**CITY OF AUSTIN
Board of Adjustment
Decision Sheet**

CASE NUMBER: C15-2019-0055

ADDRESS: 2803 EDGEWATER DR

BOA Case # C15-2019-0055
2803 EDGEWATER VARIANCE REVISION NOTES

SITE PLAN @ STREET LEVEL

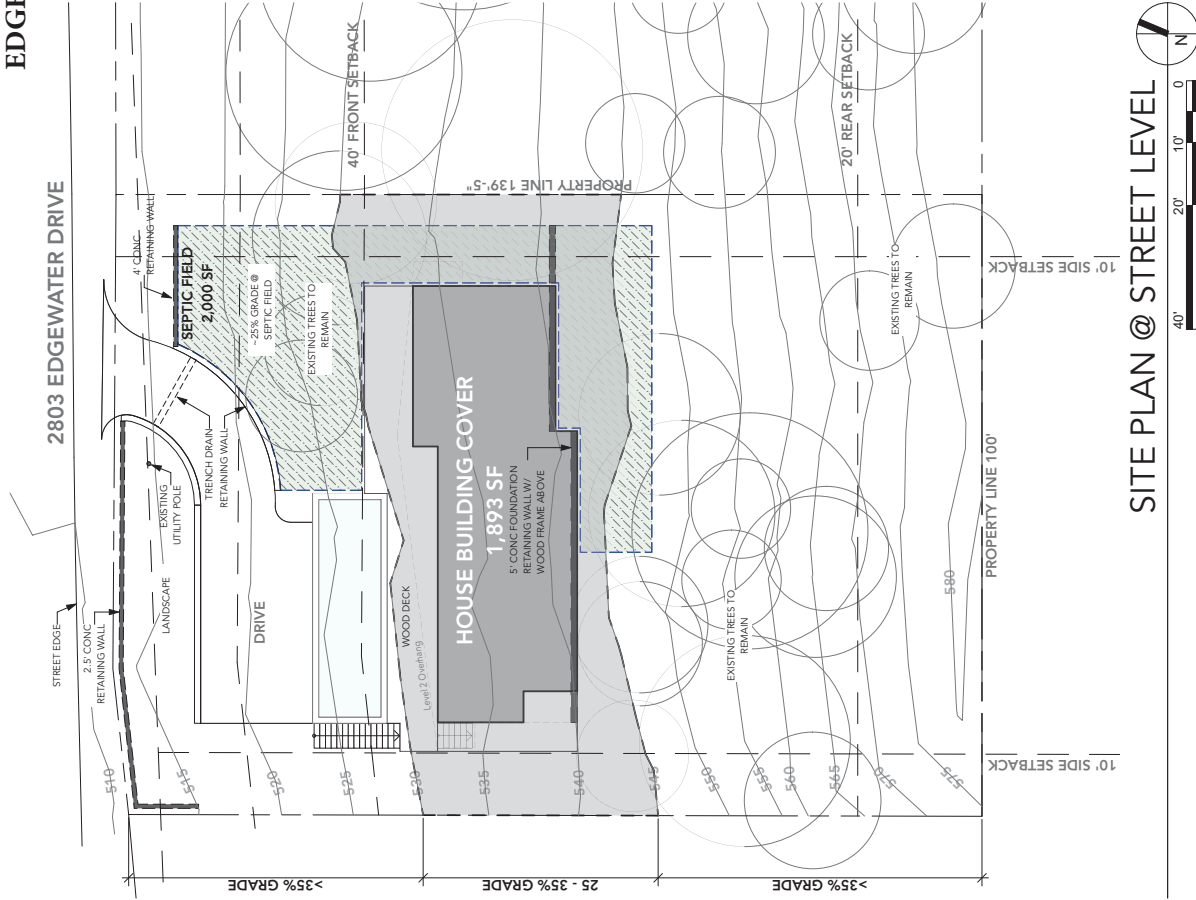
1. Building Footprint of house has decreased from 2,233SF to 1,848 SF
2. Impervious cover at 25%-35% Zone has decreased : from 66% to 60%
3. Impervious cover Over 35% Zone has decreased : from 29% to 19%

- a. **Driveway** exists in the over 35% zone which is allowed per code.
4. Structural Engineer has provided a letter indicating that Pier and Beam is not a viable solution for this project.

REVISED IMPERVIOUS COVER TABULATIONS BOA HEARING 01/13/20

SLOPE GRADE	ALLOWABLE % PER ZONE	PROPOSED % PER ZONE	ALLOWABLE SF PER ZONE	PROPOSED SF PER ZONE
0-15%	-	35%	-	-
15-25%	-	10%	-	-
25-35%	3,892 SF	5%	196 SF	2,324 SF
OVER 35%	10,043 SF	0%	0 SF	1,876 SF
		TOTAL	196 SF	4,200 SF

SITE SECTION @ HOUSE

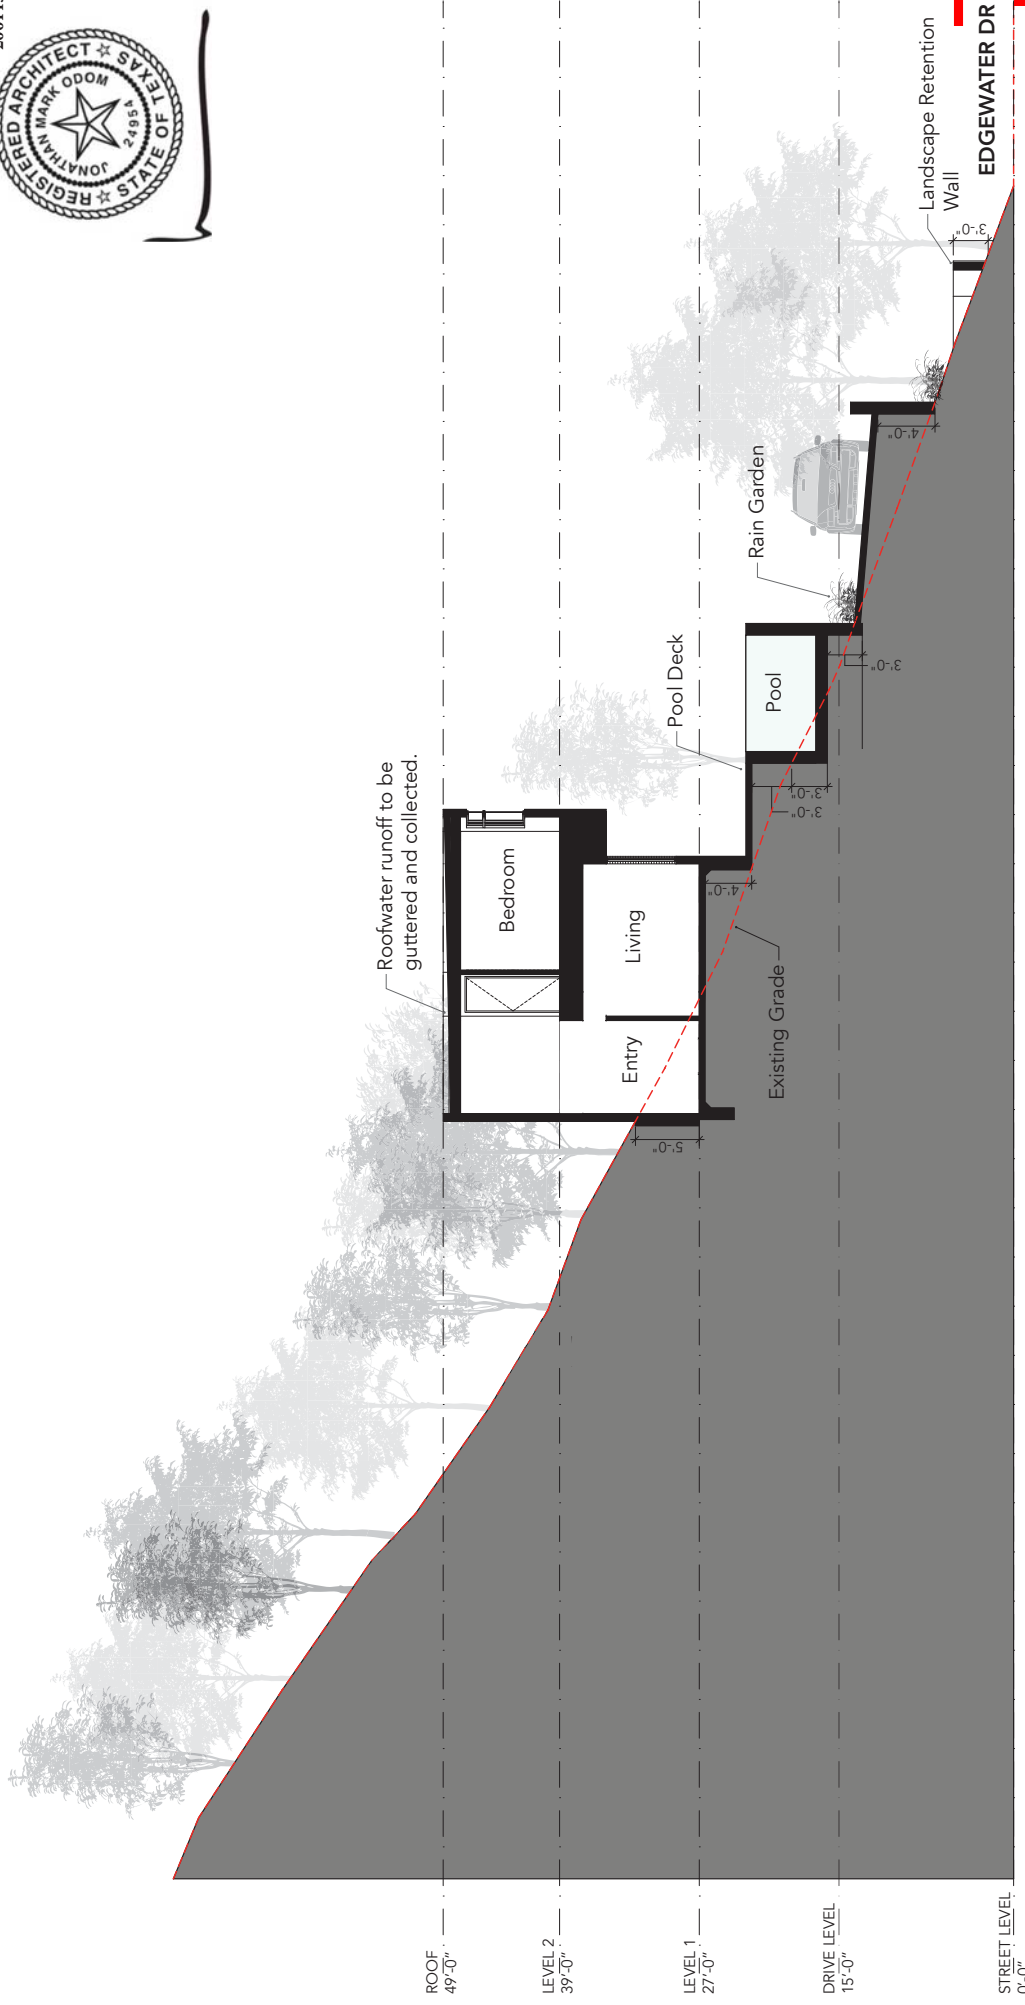
5. Soil Report indicates Bedrock below 24 inches.
6. Cut and Fill minimized and balanced per section : Retaining walls are limited to 4 feet per code
7. Foundation retaining walls are allowed to rise above 4 feet per code.
